U.S. NUCLEAR REGULATORY COMMISSION
FINAL SAFETY EVALUATION FOR
TOPICAL REPORT WCAP-16996-P/WCAP-16996-NP, VOLUMES I, II, AND III, REVISION 1,
“REALISTIC LOSS-OF-COOLANT ACCIDENT EVALUATION METHODOLOGY
APPLIED TO THE FULL SPECTRUM OF BREAK SIZES” (TAC NO. ME5244)
WESTINGHOUSE ELECTRIC COMPANY
PROJECT NO. 700

Figure 1: A Characteristic PCT Response to Break Size Variation Observed in Analyses Using 10 CFR Part 50 Appendix K and in Power Uprate Small Break LOCA Analysis

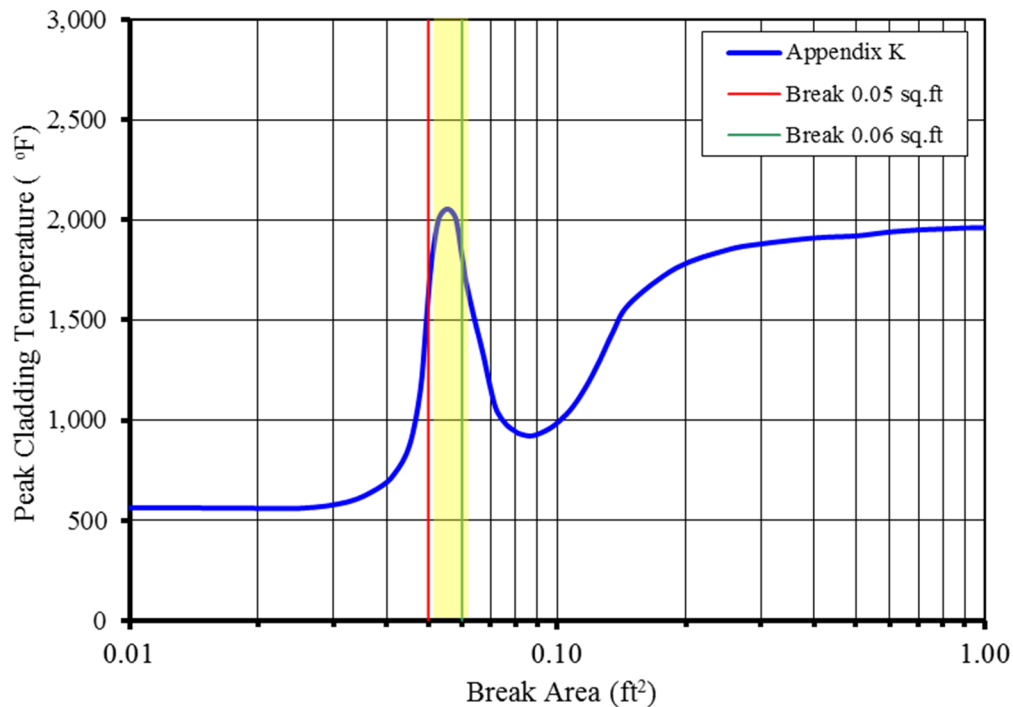
A typical small break spectrum analysis produces a characteristic PCT versus break size response, which is shown in Figure 1. Of particular significance in this response is the observed limiting break region with a maximum in the PCT at approximately 0.055 ft². The depicted PCT vs break size curve is typical of plants with low capacity high pressure safety injection pumps or those undergoing extended power uprates. It is important to further note that for some plants the predicted PCT can increase by a few hundred degrees Fahrenheit when the break size changes within the limiting break region from approximately 0.05 ft² to 0.06 ft². For example, it has been observed for many PWR plants that the PCT can increase by ~100 °F when the break area changes by as little as 0.005 ft² within this break region so that the PCT at a 0.055 ft² break is considerably higher than the PCTs at both 0.05 ft² and 0.06 ft² breaks. Furthermore, this limiting break region is characterized by a RCS pressure that depressurizes to a pressure value just above the safety injection tank (SIT) or accumulator actuation pressure. Because such behavior characterizes a large number of PWR plants, it is necessary to resolve the limiting break region confining the worst break controlled entirely by the high pressure injection pump. The core uncover period for breaks in this limiting range of relatively small breaks can be as long as 45 minutes to one hour. For some plants, the two-phase mixture level in the core can recede slowly to depths near the core mid-plane during this period. Such long term core uncover LOCAs emphasize the significance of the BE two-phase level swell modeling and PCT, controlled by interfacial drag, steam cooling heat transfer, loop seal clearing behavior, decay heat, and condensation at the safety injection port, to name the most significant. Clearly, with the core being uncovered for a period of up to one hour, very small changes in the core two-phase mixture level during such uncover periods can result in very large PCT changes.

Thus, the modeling of two-phase level swell is perhaps the most important of the phenomenological models governing the small break LOCA response.

Given the above discussed issues and the fact that the WCOBRA/TRAC-TF2 code has no proven history of successful simulation of SBLOCAs, the NRC staff formulated the following approach to identifying and analyzing the limiting break region for the SBLOCA spectrum as illustrated in Figure 1. The entire small break spectrum (Region I) is defined as:

In general, the limiting break region will lie between 2 inches and 4 inches in equivalent break diameters in the cold leg, but may differ slightly due to plant power level, geometry, and ECCS characteristics. [

To provide adequate resolution, a large number of runs, using diameter increments of 0.1 inch, for example, are to be performed for small break sizes between 2 inches (0.0218 ft²) and 4 inches in diameter (0.0873 ft²) [] The analysis of this 2- to 4-inch diameter limiting break range should be conducted using the approach [] with some additions that include the following assumptions specific to Region I analysis.
